PLANNING PERMISSION REF: 25/01047/FULLN

PROPOSED STOPPING UP OF HIGHWAY AT WESTERN AVENUE, ANDOVER, HAMPSHIRE

REBUTTAL PROOF OF EVIDENCE

HIGHWAYS AND TRANSPORTATION

Figure 1: Bus and HGV movement conflict

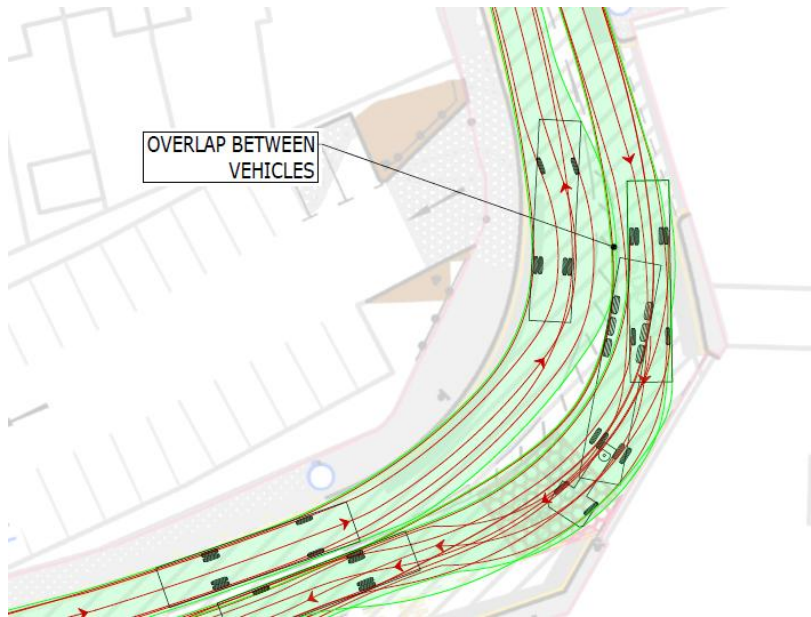
- 5.7. The C&A Report raises concerns over two vehicle movements arising from the Development layout on West Street:
- A bus and HGV opposing one another on the bend outside of the Waitrose servicing area
 - HGV 'Left-out' manoeuvre from Lidl
- 5.8. Drawing 26-081-001 was provided as part of the C&A Report which shows the swept path of a standard 11.8m bus northbound and a 16.5m articulated lorry southbound. The drawing shows a conflict point between the two vehicles at the bend of West Street adjacent to the servicing yard behind Waitrose. A snip of this drawing is shown in Figure 1 below.

- 5.9. I am of the opinion that the swept path analysis of the northbound bus is not a true reflection of the movement as the northbound bus is able to undertake a tighter turn than what is shown in the C&A report. The swept path analysis undertaken by Hampshire Engineering Services and submitted with the application for the Development (CD/5.1.16) (Drawing CJ009625-HEH-HGN-40012558-DR-CH-1000) shows that the northbound bus does not encroach onto the proposed hatching. A snip of (CD/5.1.16) is shown in Figure 2 below.

Figure 3: Southbound HGV swept path analysis

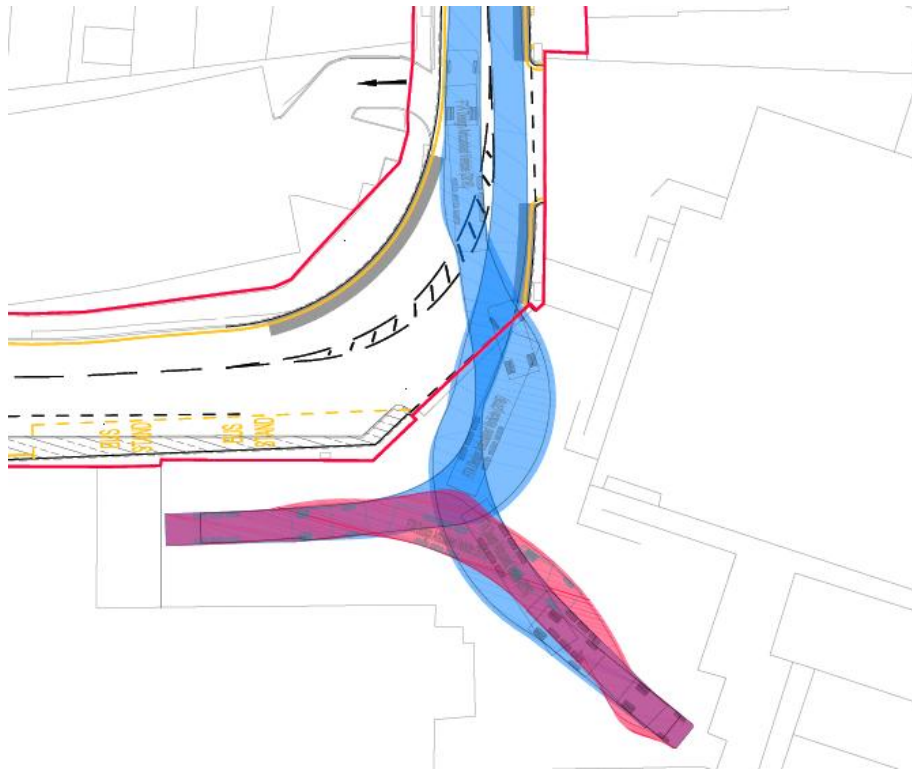
- 5.11. (CD/5.1.16) shows that, when moving southbound, the articulated vehicle does not encroach onto the proposed central white line hatching when undertaking the correct movement into the delivery area behind Waitrose. A further snip from (CD/5.1.16) is shown in Figure 3 below. As neither the northbound bus movement, nor the correct southbound HGV movement encroach on the hatching, there would be no operational issues with these movements.

- 5.12. It should also be noted that the manoeuvre would be undertaken by a professional HGV driver who will exercise increased caution when undertaking tighter movements.

Figure 4: HGV Lidl exit manoeuvre (CD/5.1.16)

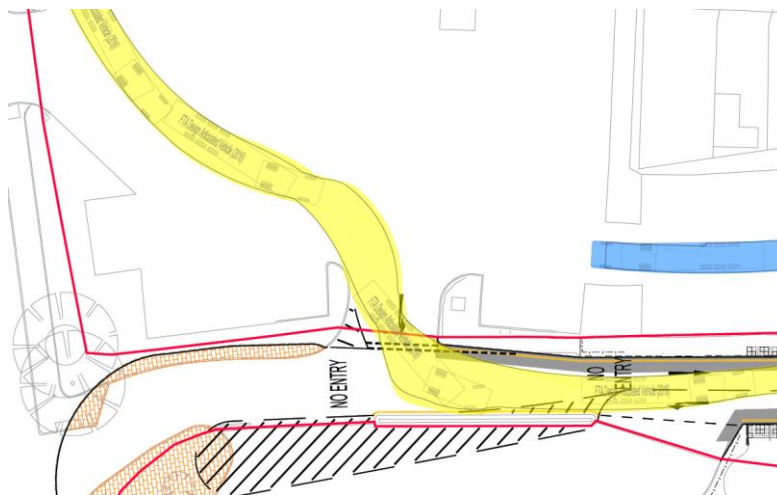
- 5.13. It was also highlighted at paragraph 3.1.5 of the C&A Report that the 'left-out' manoeuvre from the Lidl supermarket required by the Development was extremely tight for HGVs and could not easily be replicated. The swept path analysis in (CD/5.1.16) shows that the movement can be safely undertaken, and this was agreed with the highway authority. The relevant snip from (CD/5.1.16) that demonstrates this movement is shown in Figure 4 below.

- 5.14. It should also be noted that the manoeuvre would be undertaken by a professional HGV driver who will exercise increased caution when undertaking tighter movements.
